Project	IEEE 802.16 Broadband Wireless Access Working Group < http://ieee802.org/16 >	
Title	Network Entry Through an RS with Distributed Security	
Date Submitted	2007-09-05	
Source(s)	Hang Zhang, Peiyong Zhu, Mo-Han Fong, Wen Tong, David Steer, Gamini Senarath, G.Q. Wang, Derek Yu, Israfil Bahceci, Robert Sun and Mark Naden Nortel 3500 Carling Avenue Ottawa, Ontario K2H 8E9	Voice: +613-763-1315 E-mail: wentong@nortel.com Voice: +613-765-8983 E-mail: pyzhu@nortel.com
Re:	IEEE P802.16j/D1: IEEE 802.16j working group letter ballot #28	
Abstract		
Purpose	To incorporate the proposed text into the P802.16j/D1 Baseline Document	
Notice	<i>This document does not represent the agreed views of the IEEE 802.16 Working Group or any of its subgroups. It represents only the views of the participants listed in the "Source(s)" field above. It is offered as a basis for discussion. It is not binding on the contributor(s), who reserve(s) the right to add, amend or withdraw material contained herein.</i>

Network Entry through an RS with Distributed Security

Figure xxx. An example of MS initial network entry through an RS in moving BS mode.

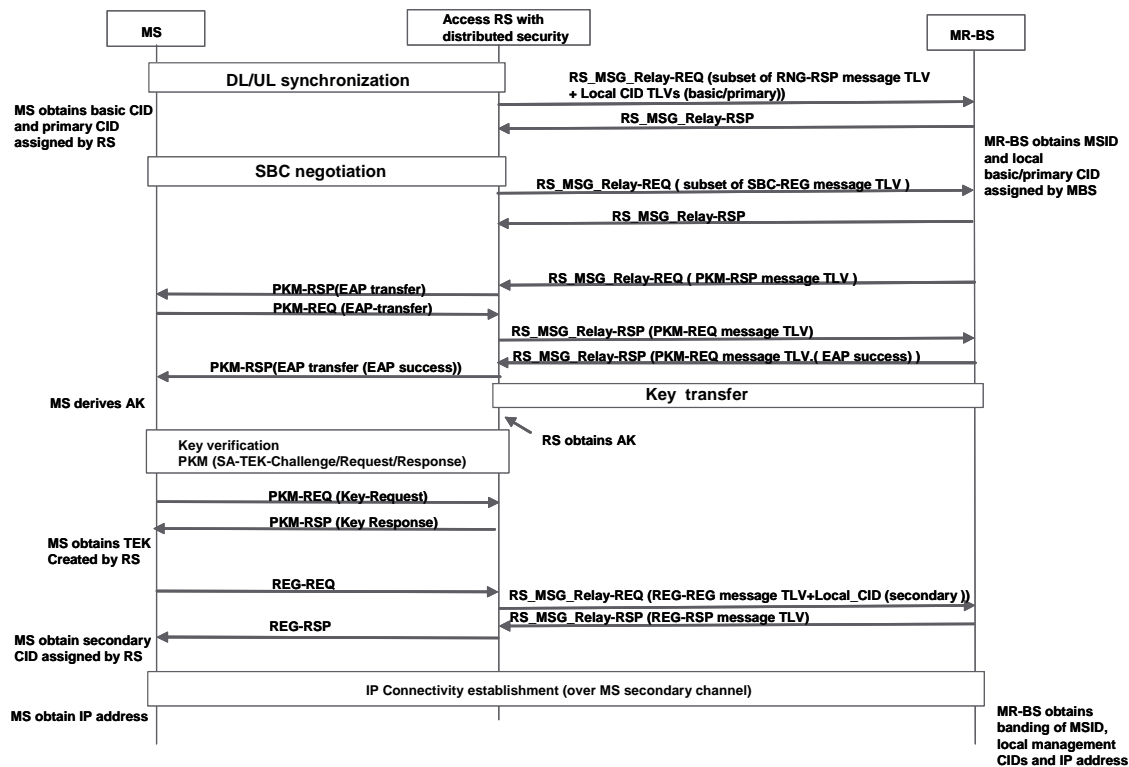
[Add the section 6.3.9.16.5 as followings]

For MS initial network entry though an access RS with distributed security, some messages such as RNG-REQ/RSP and SBC-REQ/RSP can be locally processed first then the attachment of a MS is informed to the MR-BS. The information carried in messages such as PKM-REQ/RSP and REG-REQ/RSP need to be forwarded to MR-BS and the corresponding response of MR-BS needs to be forwarded to MS. The MS initial network entry through an RS with distributed security is illustrated in Figure XXX.

- DL/UL synchronization
 - For DL synchronization, no any additional requirement for an access RS in moving BS mode
 - During MS UL synchronization, the RS shall locally assign a basic CID and a primary CID to the MS

- After the MS DL/UL synchronization, the RS may send RS MSG Relay-REQ message to MR-BS which include the following TLVs of RNG-REQ/RSP (those TLVs may be transmitted to MR-BS after SBC-REQ/RSP exchange)

- SS MAC Address
 - Basic CID and primary CID (locally assigned to the MS)
 - The MR-BS shall response with RS MSG Relay-RSP message
 - No TLV of RNG-RSP TLV is included

- After the MS DL/UL synchronization, the MR-BS establishes a binding between the MS ID and the basic CID and primary CID locally assigned by the RS
- Basic capability negotiation

- A MS and an access RS negotiate the basic capability locally through SCB-REQ/RSP messages without involvement of MR-BS
 - After the negotiation between the MS and the RS, the RS shall send RS MSG Relay-REQ message to MR-BS. The following TLVs of SBC-REQ message may be included

- Security Negotiation Parameters
 - MR-BS shall send RS MSG Relay response message to the access RS as a response to RS MSG Relay-REQ sent from the access RS

- No TLV of SBC-REQ/RSP TLV is included
 - RS MSG Relay-RSP message may includes the TLVs of RNG-REQ/RSP messages if the access RS decides to combine those information together with those of SBC-REQ/RSP

- MS authorization/authentication (EAP case) and MS key establishment
 - The MR-BS may trigger the MS authorization/authentication by sending RS MSG Relay-REQ message to an access RS including the fields of PKM-RSP and

- EAP transfer attributes of PKMv2 EAP Transfer message
 - The access RS creates PKM-RSP message by including the above contents and sends to the MS
 - The MS sends the PKM-REQ (PKMv2 EAP Transfer) message to the access RS

- The access RS then creates RS MSG Relay message by including following
 - fields of PKM-REQ (PKMv2 EAP Transfer) received from the MS
 - EAP transfer attributes of PKMv2 EAP Transfer message received from the MS

- After the AK of the MS is available by MR-BS, the MR-BS shall deliver the AK through AK transfer to the access RS
 - The access RS and the MS then shall use PKMv2 3-way handshake to verify the AK and use PKMv2 Key-request/Reply exchange to make the MS obtain valid TEK keys. These message exchanges only happen between the access RS and MS without the involvement of MR-BS

- MS registration to the network
 - MS sends the REG-REQ message to the access RS. The RS shall include the following TLVs from the received REG-REQ message in RS-MSG Relay-REQ and send this RS MSG Relay-REQ to MR-BS:

- IP version
 - Vendor ID encodings
 - Vendor-specific information

- Secondary CID locally assigned by the access RS
 - MR-BS creates RS_MSG_Relay-RSP message by including the following TLVs of REG-RSP message:
 - IP version
 - Vendor ID encodings
 - Vendor-specific information
 - Access RS creates the REG-RSP message and sends the message to the MS
- MS IP connection establishment
 - All MS IP connection related protocol messages are viewed as a type of service flow with an assigned QoS class. Those messages are exchanged between the MR-BS and the MS though the MS's local secondary connection over the forwarding transport connection (F-CID) between the access RS and the MR-BS
